Access Compliance Report

Public Rights-of-Way

Intersection ID: 48581	Main Street: WATERLILY_LN	Cross Street: RUMPLE_RD	Location: SE
ADA ID: 4C4AC3378533	Ramp Type: ParaDiag	Initial Pass/Fail: Pass	Overall Compliance: No
		Severity Score: 0

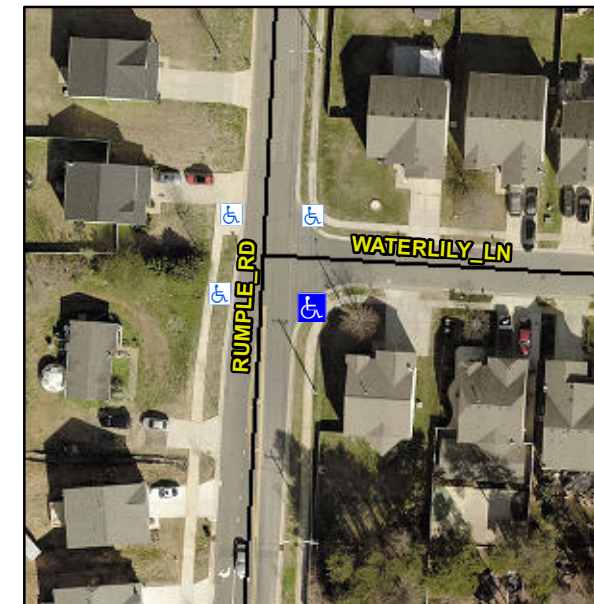
R304.5.3, R305.2

Remove & Replace Curb Ramp With Two New Directional Ramps or Equivalent. Remove & Replace Gutter.
